**TO:** DEVELOPMENT REVIEW BOARD **DATE:** September 4, 2003  
**FROM:** CURRENT PLANNING SERVICES  
**SUBJECT:** CASE 61-DR-2003  
**REQUEST:** Approve site plan & elevations for a new 71-acre City park  
**PROJECT NAME:** C.A.P. Basin Park  
**LOCATION:** NEC Hayden Rd & Bell Rd

# **Stipulations for Case: C.A.P. Basin Park 61-DR-2003**

## **PEDESTRIAN BRIDGE**

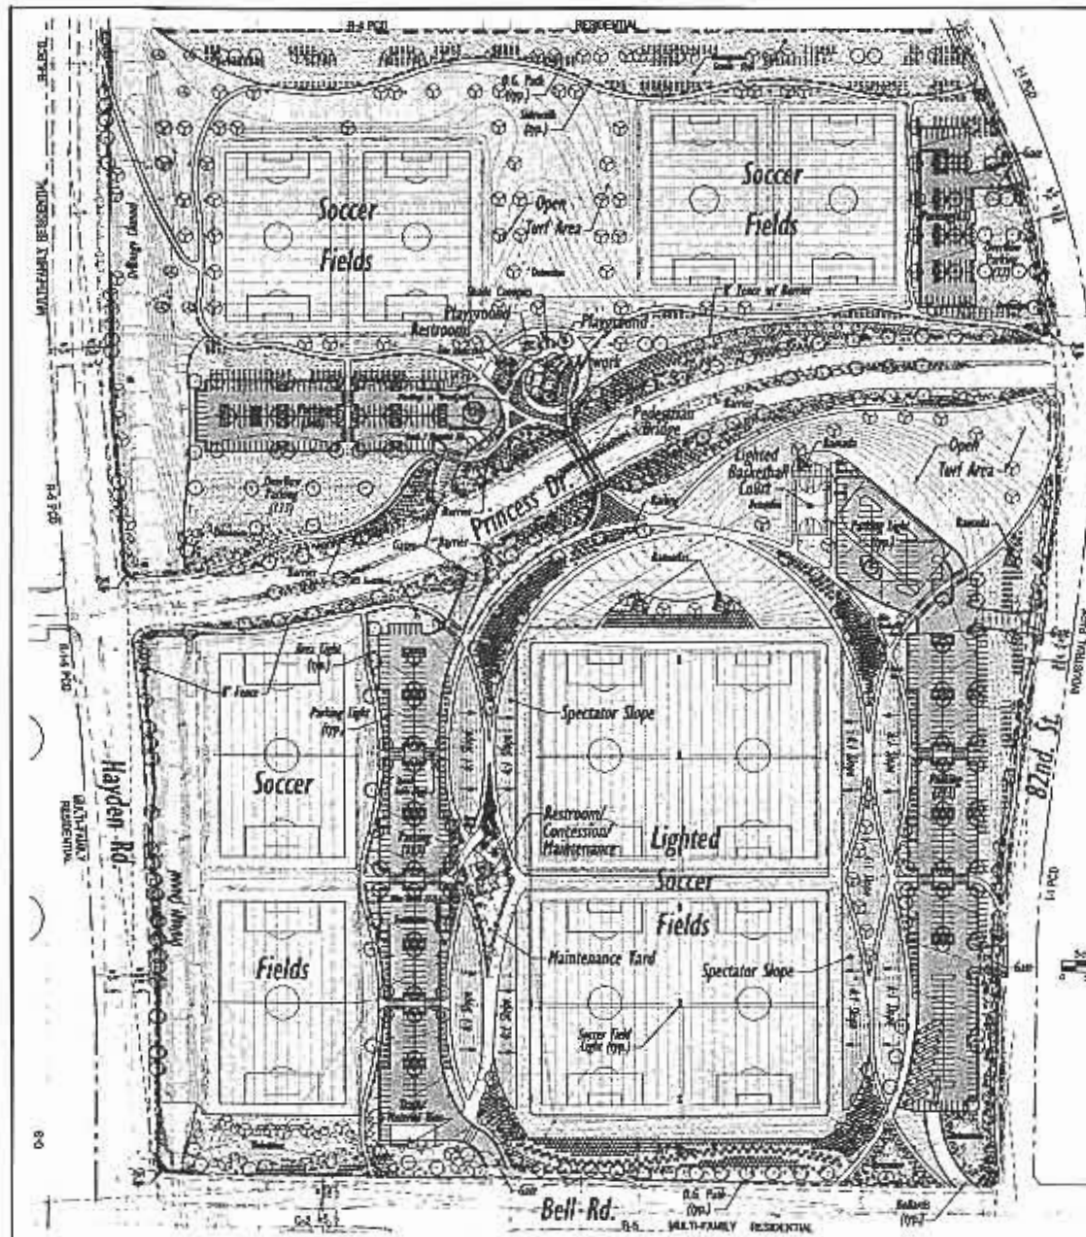
9. All walls shall match the architectural color, materials and finish of the building(s).
10. The pedestrian bridge crossing at Princess Drive shall have rock columns. The material and finish schedule shall be subject to the approval of the Project Coordination Manager.
